CUSTOMER TECHNICAL MEMO # 496

Subject: McArthur Evo Centre Pocket Date: 30th November 2021

Framing Update

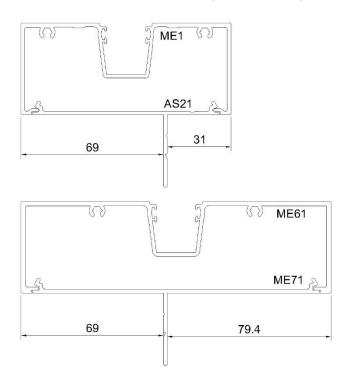
The ME27 – 101.6mm Flashing Adaptor has been designed with the reveal to be exactly in the middle of the adaptor. This will enable fabricators to avoid confusion when assembling the reveal.

The ME71 – 150mm Flashing Adaptor has been designed so the reveal is back 69mm which is the reverse of the AS21. Please see below picture example.
